DESIGN RESPONSE

FINAL CONSULTATION (ONLINE)

Skatepark Plan

FINAL DESIGN

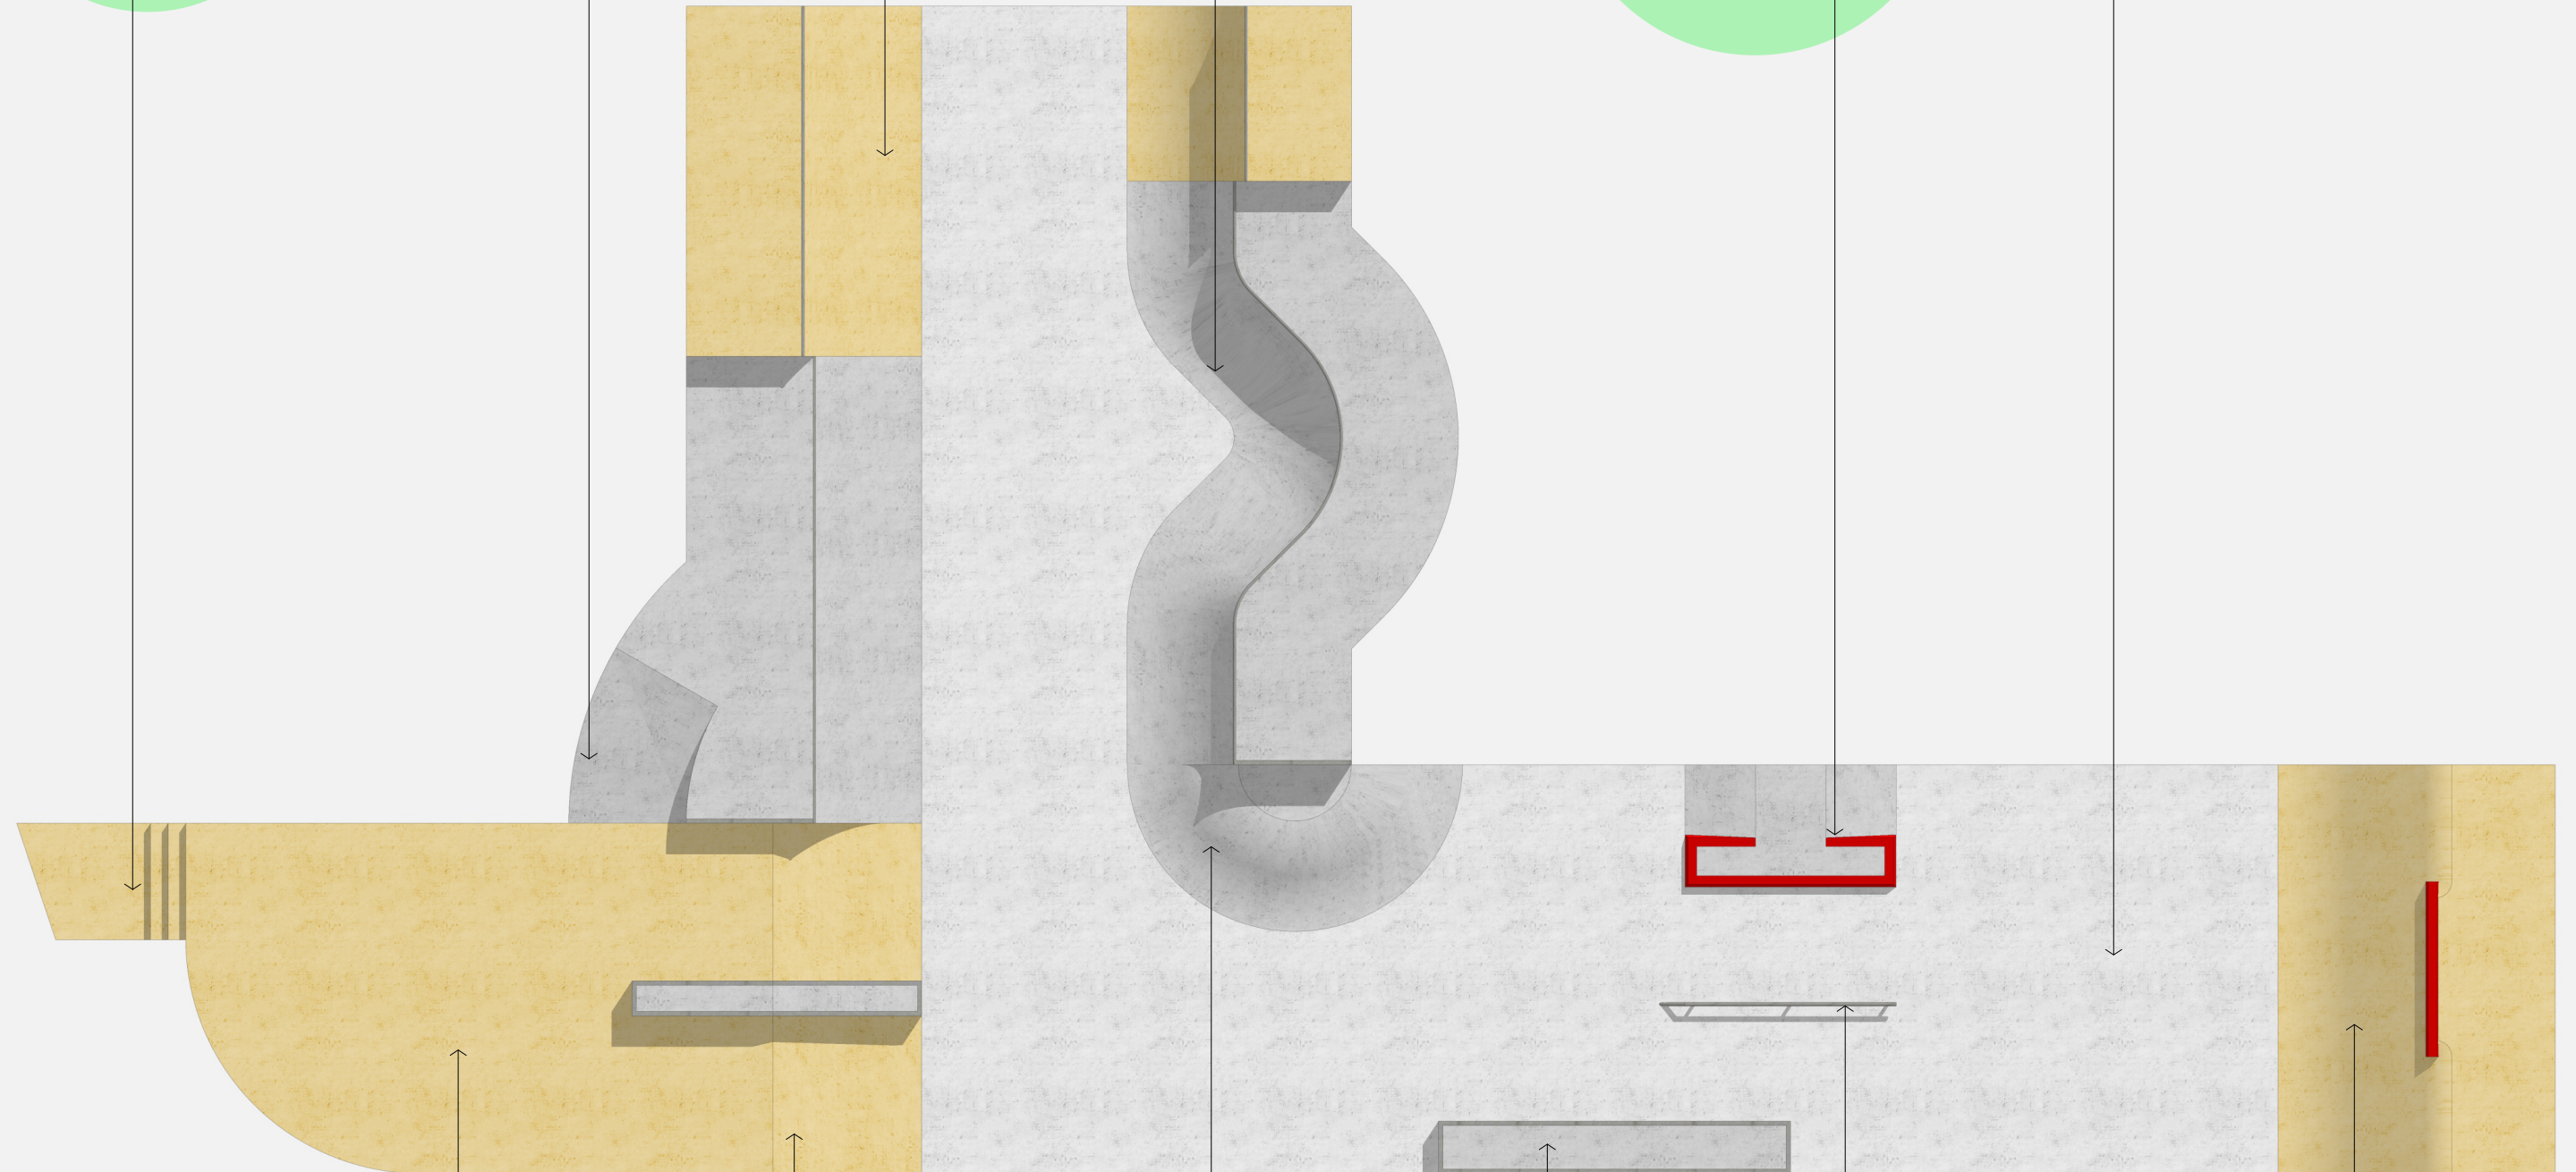
LOOKING GOOD! I'M JUST THINKING WITH THE DOWNHILL RAIL AND LITTLE STEP MAYBE EXTEND THAT WIDE ENOUGH TO ALSO HAVE A BOX TOO AND BE WIDE ENOUGH SO IT CAN BE SKATED ON BOTH SIDES OF THE BOX.

CHANGE ONE END OF THE FLAT BAR TO BE A POLE JAM.

BANK IS POINTLESS. NO SPINE OR JUMP BOX, THE MOGUL COULD EASILY BE A JUMP BOX,

BE GOOD TO HAVE A BOX JUMP COMING OUT OF THE MINI RAMP AREA LANDING NEXT TO THE PLAZA PART.

NEEDS MORE JUMPS.

WE'VE REVISED THIS OBSTACLE TO MEET THE SITE CONDITIONS BETTER (LOWER BANK) AND PROVIDED A HUBBA LEDGE THAT CAN BE USED ON BOTH SIDES. UNFORTUNATELY, THE BUDGET AND SPACE DOESN'T ALLOW FOR A HANDRAIL AND HUBBA TO BE INCLUDED. THE HUBBA IS A MORE ACCESSIBLE OBSTACLE SO WE DECIDED TO INCLUDE IT INSTEAD OF THE HANDRAIL.

GREAT IDEA! WE'VE INCLUDED THIS ON THE REVISED DESIGN.

WE HAVE INCLUDED ELEMENTS THAT AREN'T AT SURROUNDING PARKS TO OFFER POINTS OF DIFFERENCE FOR THE WIDER COMMUNITY (SPINE AND JUMP BOX FOUND AT PAKENHAM SKATEPARK). IN ADDITION, THE DESIGN HAS BEEN CONFIGURED WITH ADEQUATE SPACE BETWEEN OBSTACLES TO SAFELY USE THEM.

PAKENHAM HAS A BOX JUMP AND SPINE. IF THERE WAS A BOX JUMP IT WOULD GREATLY INCREASE THE FOOTPRINT DUE TO THE RUN-OFF AND RETURN REQUIRED, WHICH IS OUTSIDE OF THE AVAILABLE BUDGET.

UNFORTUNATELY WE CAN'T FIT ANY MORE JUMPS INTO THE SPACE, BUT WE'VE REVISED THE LONG LEDGE AND KICKER ELEMENT TO PROVIDE MORE DIVERSITY IN THE SKATEPARK AND IMPROVE THE DIRECTION OF FLOW AROUND THE SKATEPARK.
